Building #046 Renovations
For
College of Social and Applied Human Sciences
Project No. 504034

ADDENDUM 5

December 12, 2018

A5.45 DRAWING A91 – ARCHITECTURAL MILLWORK PLANS, ELEVATIONS AND DETAILS

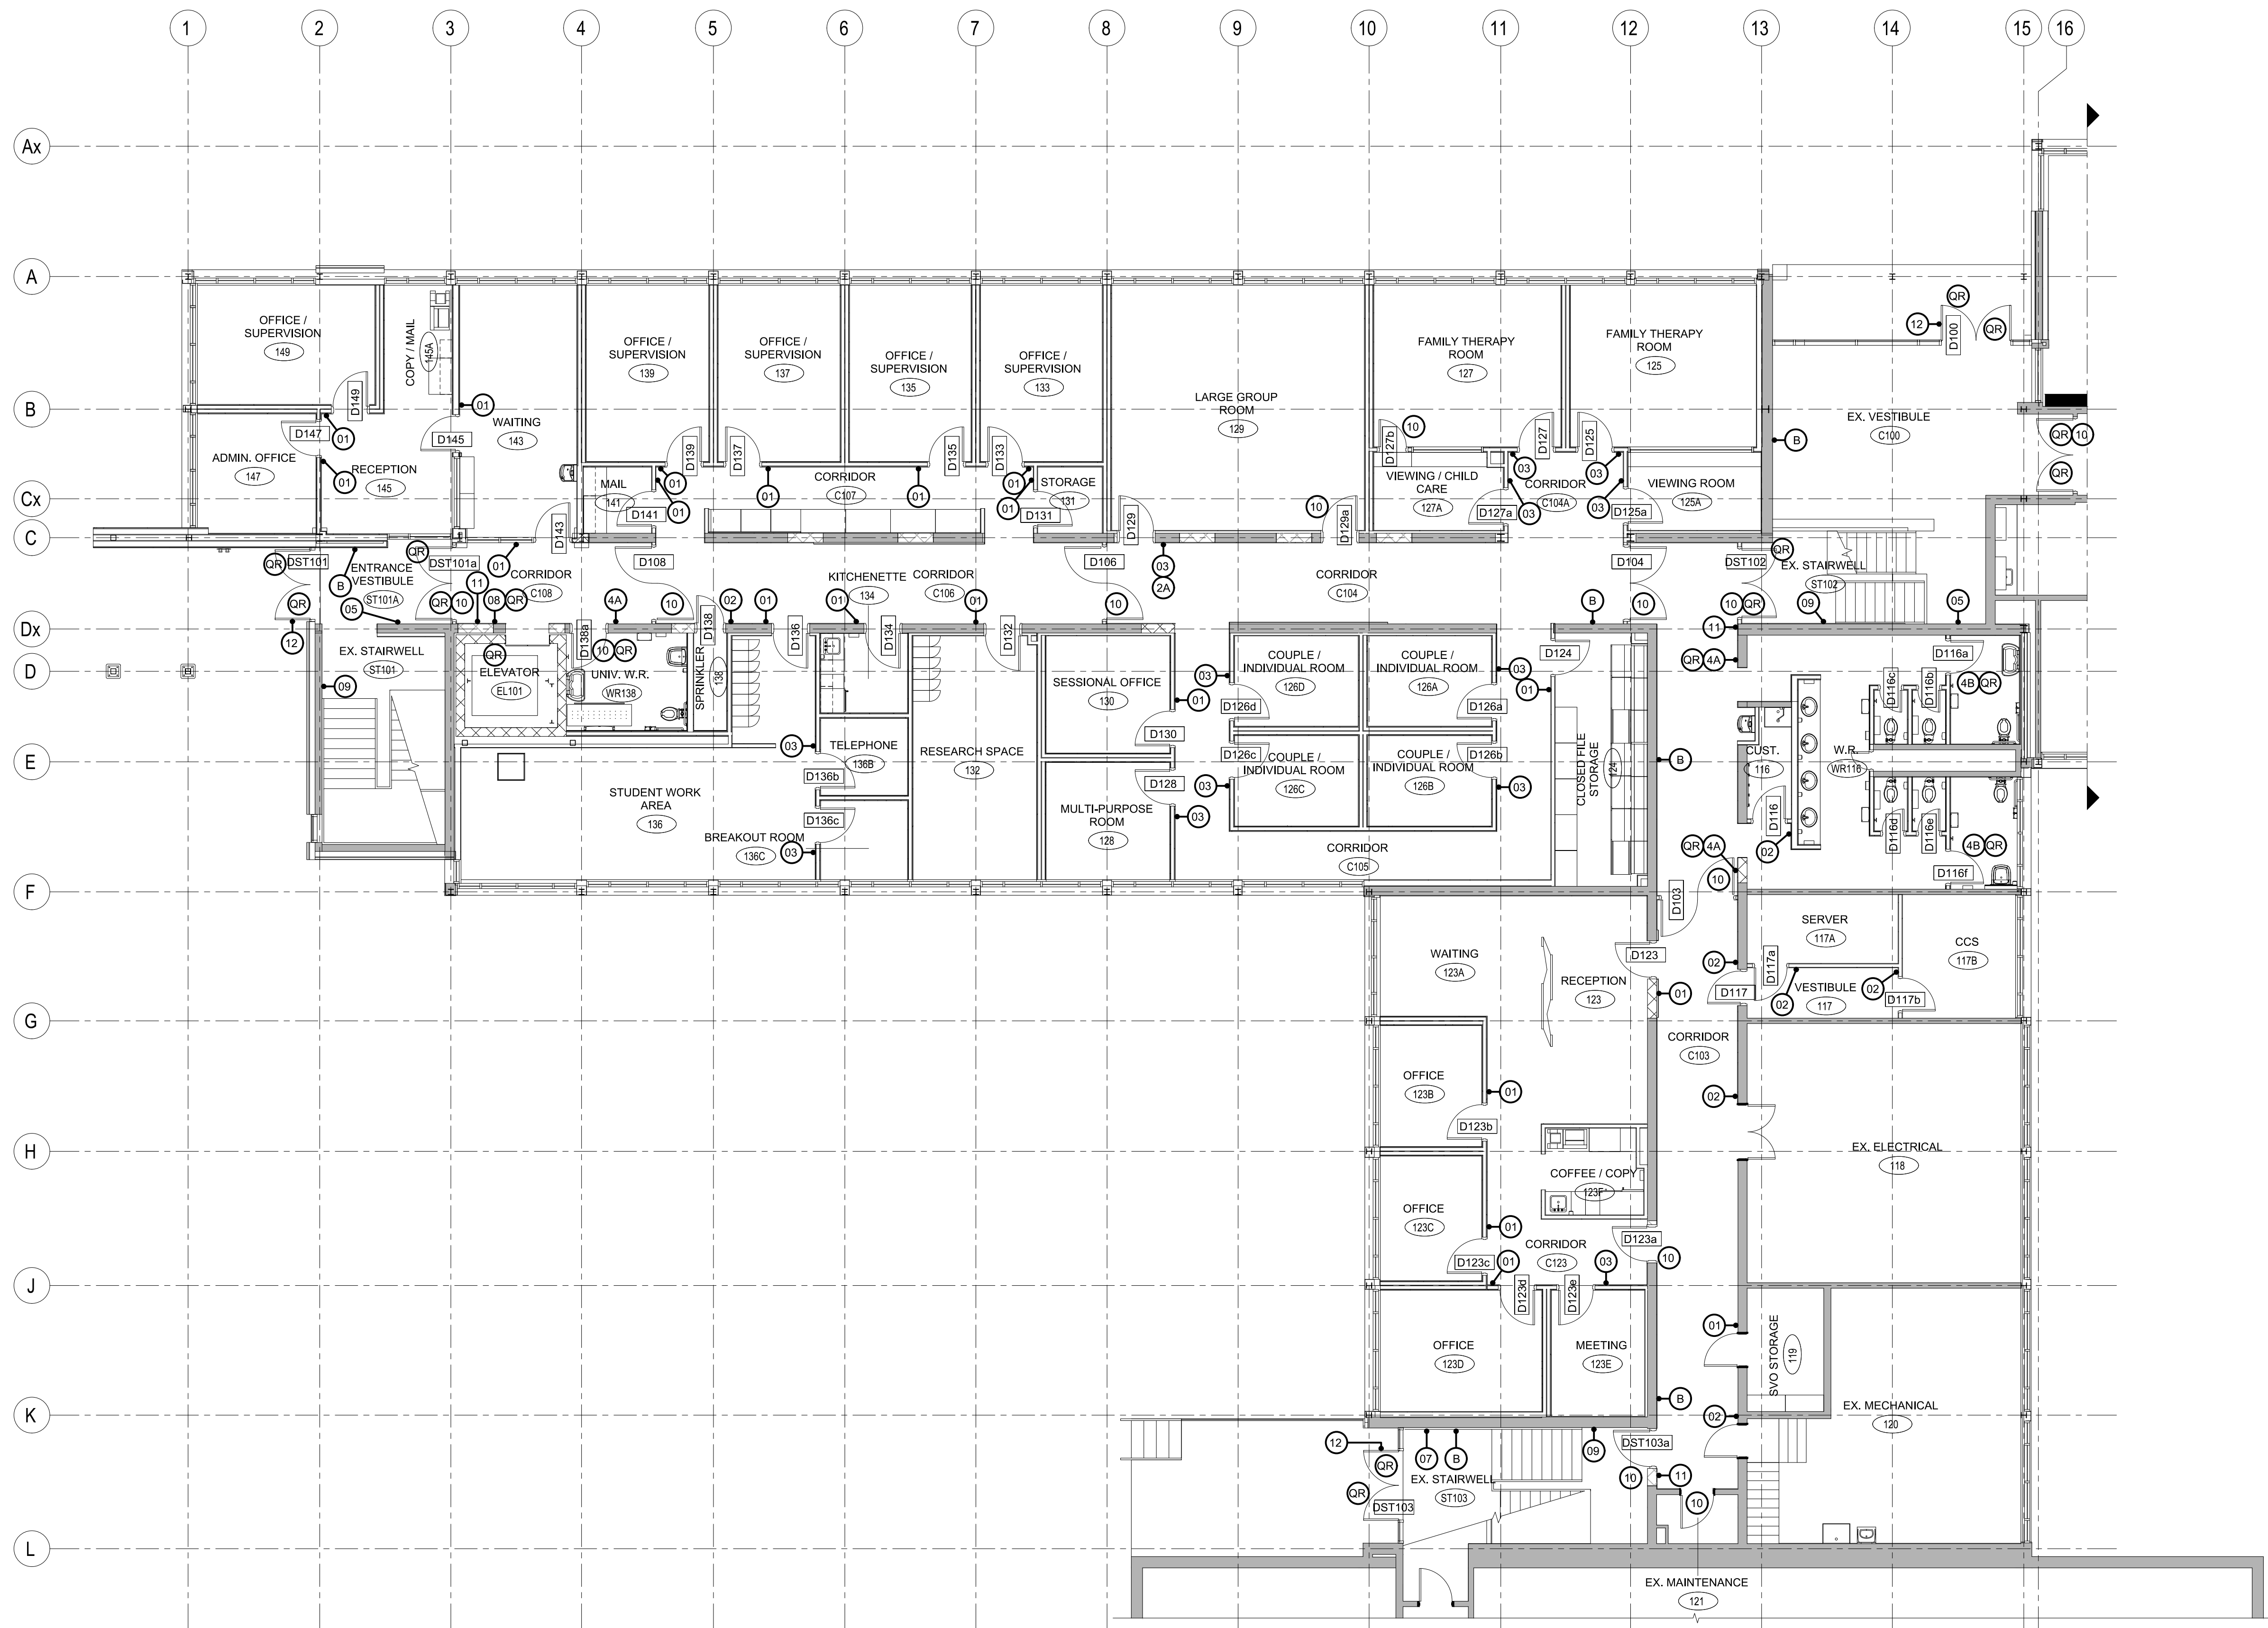
- .1 **DELETE:** 'N.I.C' from note "Key Lock Box (N.I.C)" in detail 8.
